IEEE P802.15
Wireless Personal Area Networks

Project	IEEE P802.15 Working Group for Wireless Personal Area Networks (WPANs)	
Title	TG3 D10 running comment resolutions	
Date Submitted	[8 July, 2002]	
Source	[James P. K. Gilb] [Apparent Technologies] [9921 Carmel Mountain Rd. #247, San Diego, CA 92129]	Voice: [858-538-3903] Fax: [858-538-3903] E-mail: [gilb@ieee.org]
Re:	[]	
Abstract	[This document is a record of comment resolutions for LB17.]	
Purpose	[To provide a record of the comment resolution for LB17.]	
Notice	This document has been prepared to assist the IEEE P802.15. It is offered as a basis for discussion and is not binding on the contributing individual(s) or organization(s). The material in this document is subject to change in form and content after further study. The contributor(s) reserve(s) the right to add, amend or withdraw material contained herein.	
Release	The contributor acknowledges and accepts that this contribution becomes the property of IEEE and may be made publicly available by P802.15.

1. Comment resolution, Vancouver to Schaumburg

Figure 2—MSC for the initiating of a neighbor piconet.

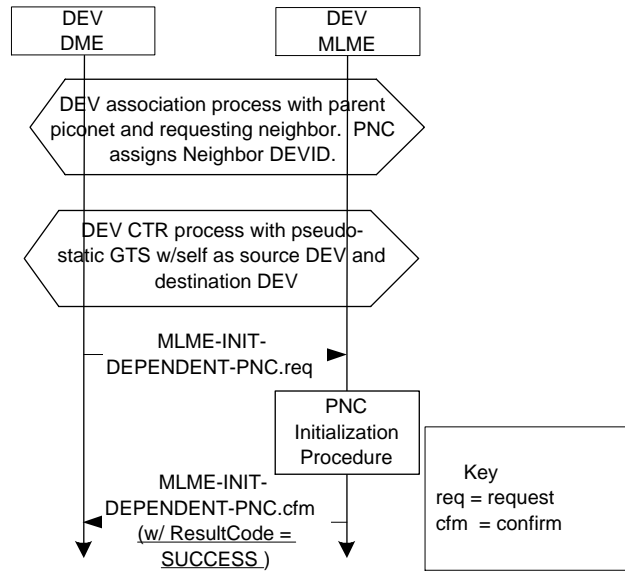
179 (Heberling, TR) - Figure 98 should be replaced with a proper MSC of the required protocol needed to establish a neighbor piconet. Replace figure 98 with a proper MSC. **Suggest accept** - An MSC for neighbor piconet initialization is included below. It needs twiddling to get the vertical lines to not show in the hex process blocks. Also, although consistent with other similar diagrams, this MSC seems to need the first beacon of the neighbor PNC shown.

Accept in principle, “Accept suggested resolution but add a line at the bottom that shows the first beacon being sent. Also add after the sentence that says ‘The MSC for the initiation a neighbor piconet is illustrated in Figure 4.’ the following sentence, ‘The association and channel time request processes are defined in xref and xref, respectively.’”

Figure 3—MSC for the creating a child piconet.

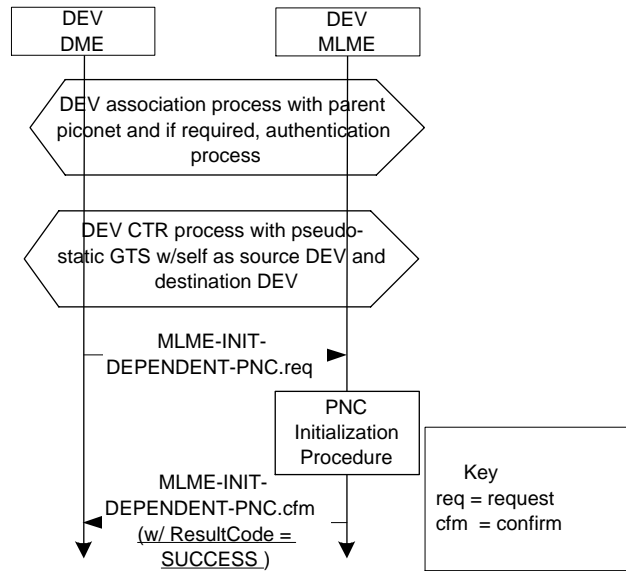
177 (Heberling, TR) - Figure 96 should be replaced with a proper MSC of the required protocol needed to establish a child piconet. Replace figure 96 with a proper MSC. **Suggest accept** 'An MSC for child piconet initialization is included below. It needs twiddling to get the vertical lines to not show in the hex process

blocks. Also, although consistent with other similar diagrams, this MSC seems to need the first beacon of the child PNC shown.

Accept suggested resolution but add a line at the bottom that shows the first beacon being sent. Also add after the sentence that says ‘The MSC for creating a child piconet is illustrated in Figure 2.’ the following sentence, ‘The association and channel time request processes are defined in xref and xref, respectively.’

Figure 4—MSC for a approved asynchronous channel time request

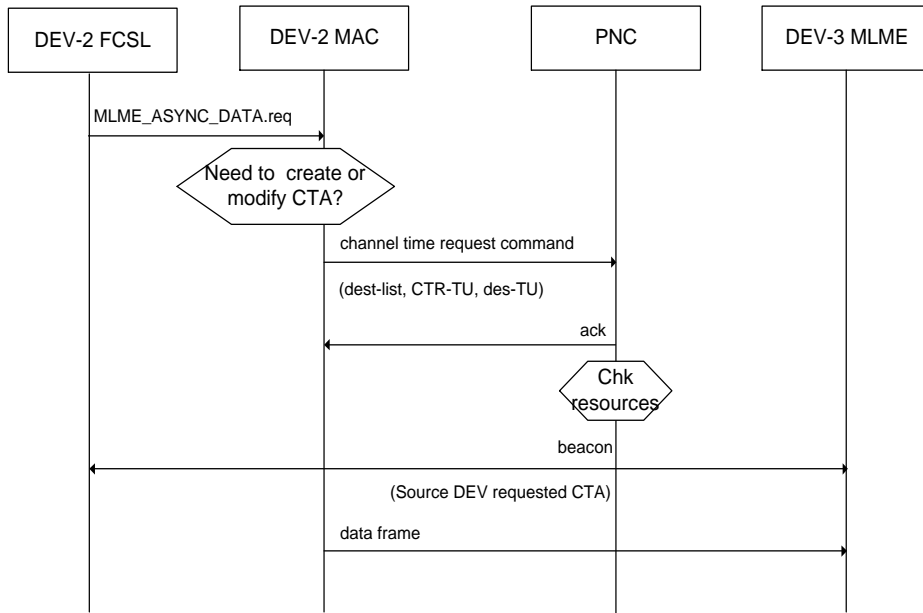
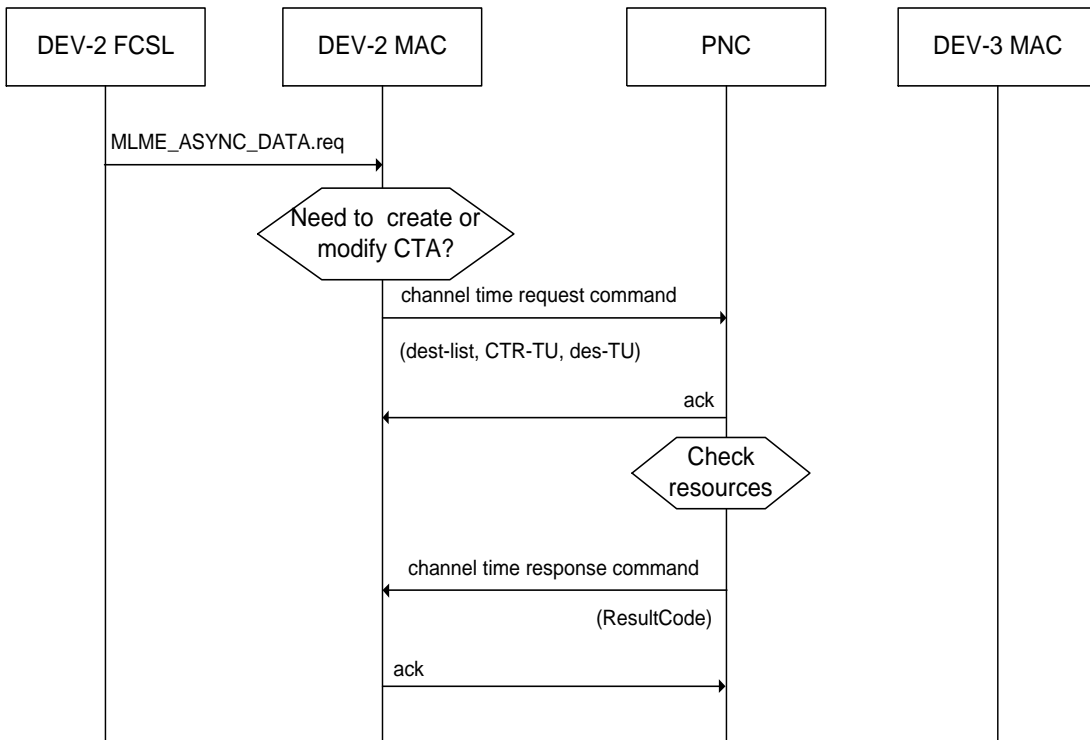
327 (Heberling, TR) Figure 119 is a flawed MSC of the Asynchronous channel time reservation process and data frame exchange. Consequently, delete the current MSC from this section of clause 8.5.2.1 and replace it with 02r0P802-15_TG3-Asynch-channel-time-allocation.eps. **Suggest accept**.

Figure 119 – MSC for reserving asynchronous data channel time. Discussed earlier, new MSC is below:

8.5.2.1 Asynchronous GTS termination: Change it to only allow the source and PNC to terminate.
